Subject: RE: NW Natural: Fill Water-Bearing Zone (WBZ) Trench Design - For Expedited Review

DEQ reviewed the “Fill Water-Bearing Zone Trench Design” dated September 28, 2020 (LNG Basin Trench Design). The LNG Basin Trench Design responds to DEQ’s September 2, 2020 comments to the Draft LNG Basin Trench Design dated August 13, 2020 (see footnote). The LNG Basin Trench Design presents the design for two trenches positioned downgradient of the Liquefied Natural Gas (LNG) Basin. NW Natural is constructing the trenches as a removal action to address groundwater contamination migrating from under the LNG Basin and towards the Willamette River. Anchor QEA, LLC prepared both design documents on behalf of NW Natural.

FILL WATER-BEARING ZONE TRENCH
 INTERIM MEASURE

**Fill Water-Bearing Zone Trench Design
DEQ Comment and Response Matrix**

C05

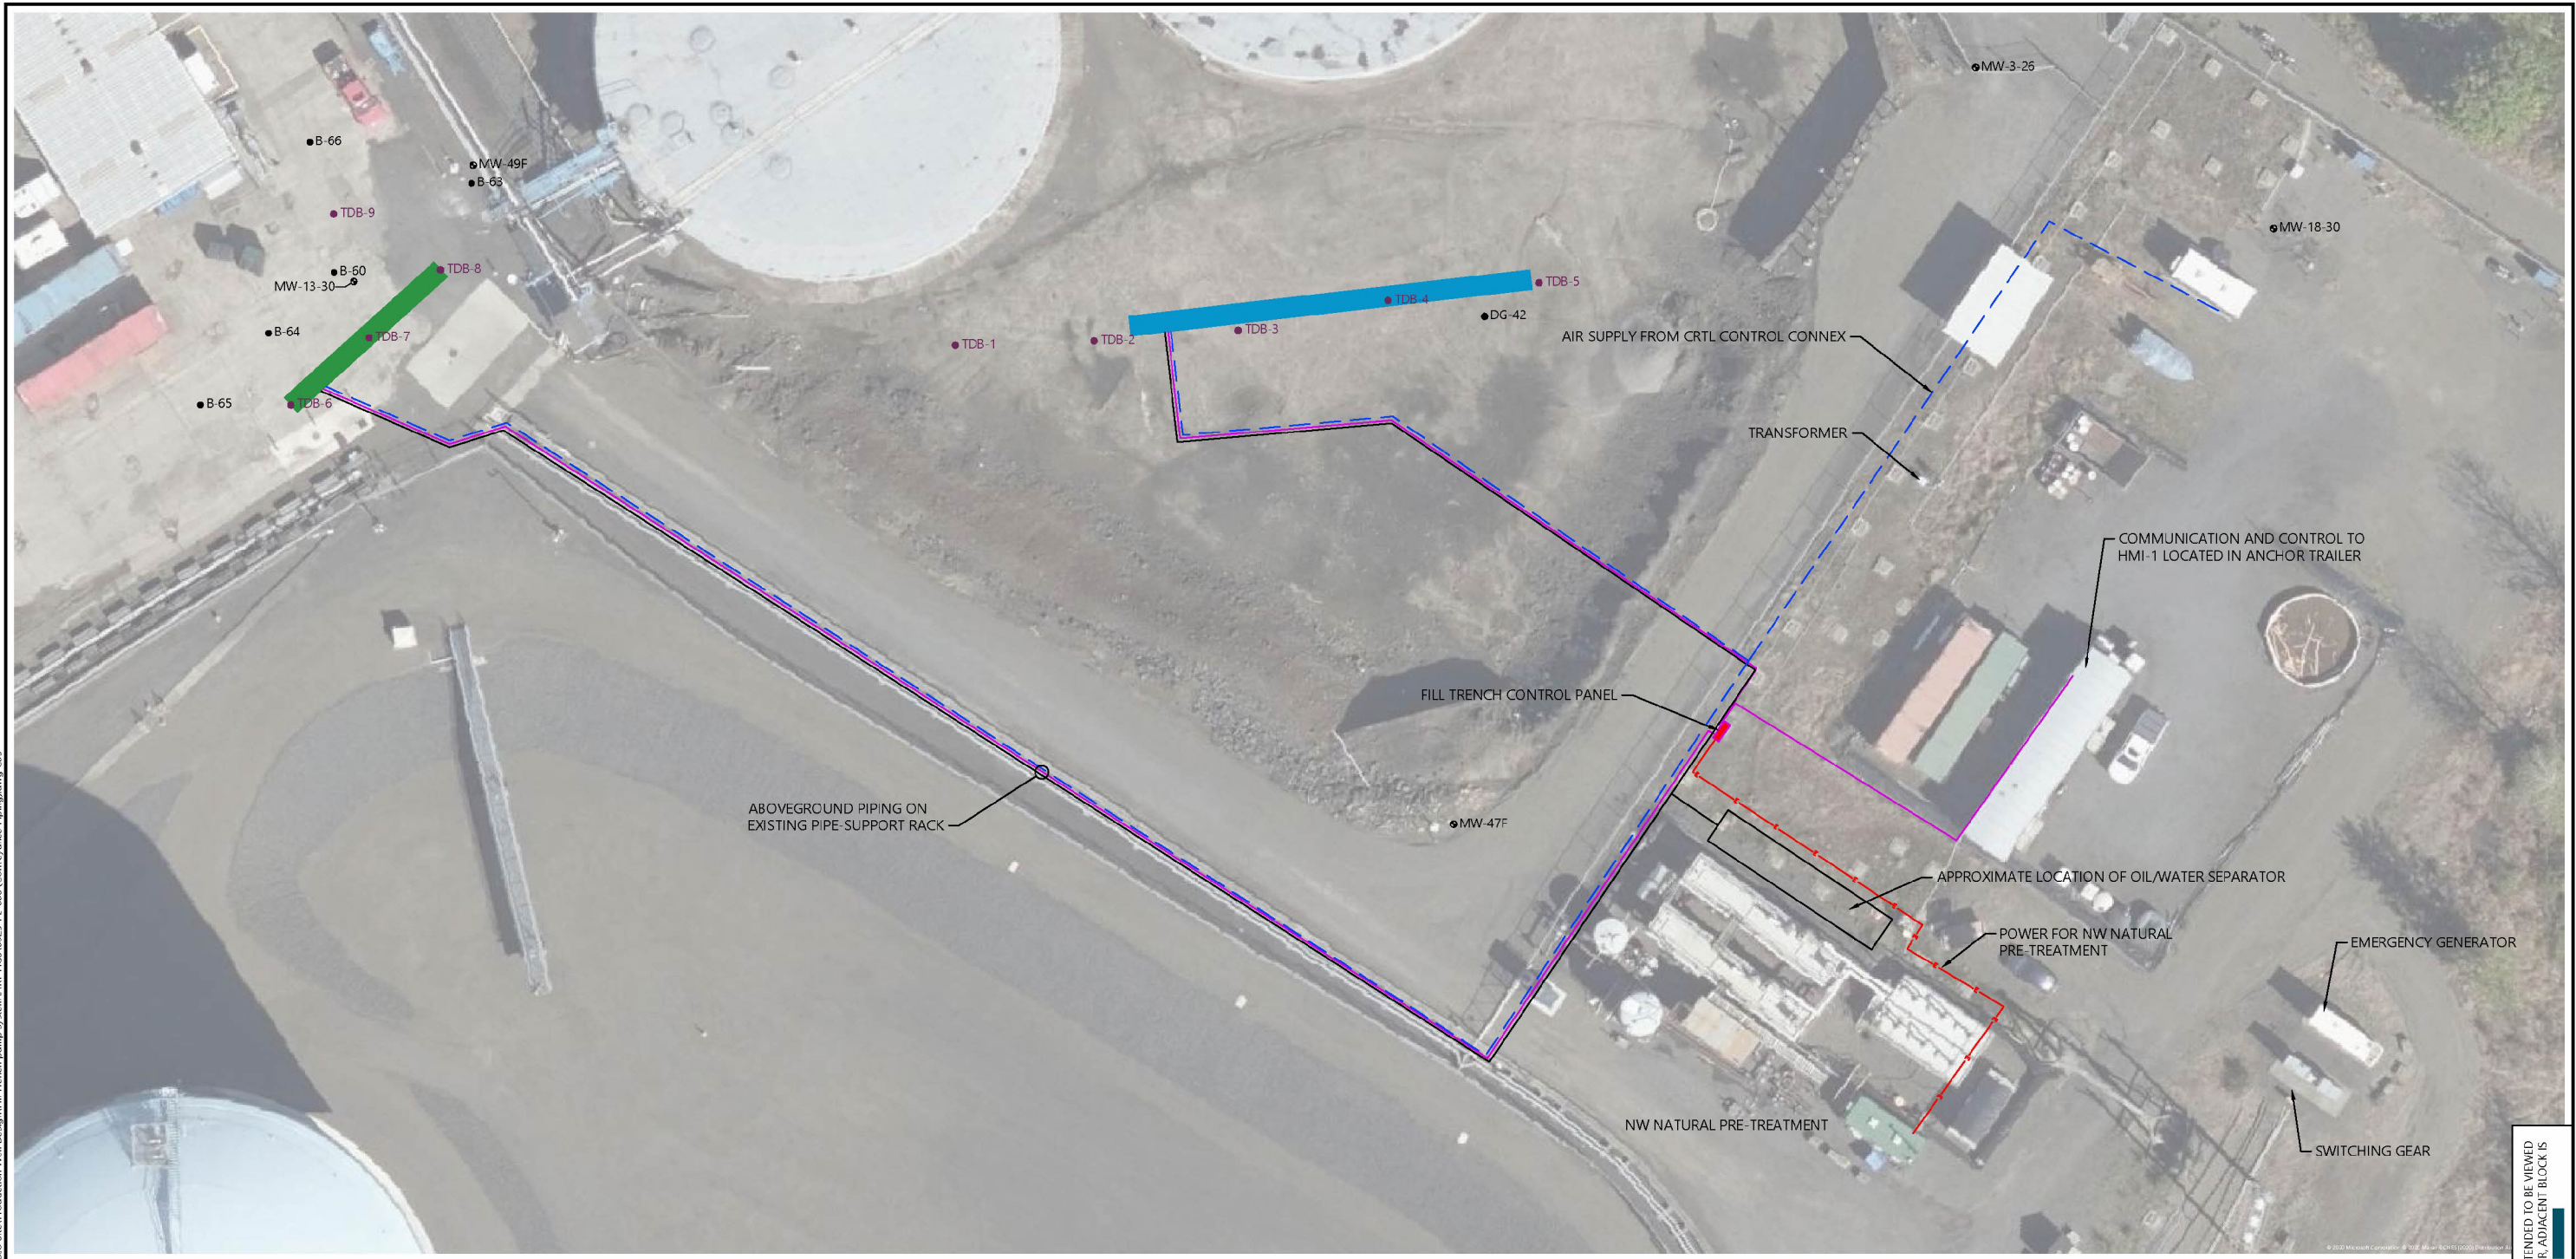
Response #25. The design adds Drawing C05 to Appendix E to illustrate conveyance piping alignments and certain features of the trench system (e.g., control panel, equalization tank) appears. The drawing appears to be incomplete. DEQ understands from Section 5.5.2 and Appendix G (see Process Flow Diagram) that the NW Natural retreatment system expansion includes essentially the same process equipment as the existing facility. DEQ requests that NW Natural confirm that the pretreatment system expansion shown in Appendix G will occupy the area between the Anchor trailer and the existing system.

- The Process Flow Diagram does not include the equalization tank shown in Figure C05 and DEQ requests information regarding the specific location of the tank in the diagram;
- Appendix G should clarify whether the diversion of flows to the system expansion involves some or all of the HC&C system extraction wells, and identify the wells if a subset of installations are involved; and
- The total capacity of the treatment system with the expansion should be provided.

8.	Response No. 25	Appendix E	Drawing C05	The design adds Drawing C05 to Appendix E to illustrate conveyance piping alignments and certain features of the trench system (e.g., control panel, equalization tank) appears. The drawing appears to be incomplete. DEQ understands from Section 5.5.2 and Appendix G (see Process Flow Diagram) that the NW Natural retreatment system expansion includes essentially the same process equipment as the existing facility. DEQ requests that NW Natural confirm that the pretreatment system expansion shown in Appendix G will occupy the area between the Anchor trailer and the existing system.	Drawing C05 has been revised (and is attached) to show the additional oil-water separator between the existing pretreatment system and the Anchor QEA trailer.

On behalf of NW Natural, attached please find responses to the Requests for Information and Clarifications listed below as well as revised Figure C05. We are excited to begin trench construction on Monday, November 2, 2020 and appreciate your expedited review and approval of September 28, 2020 Fill Water-Bearing Zone Trench Design. Please let me know if you have any questions or need additional information concerning our responses. Thanks.
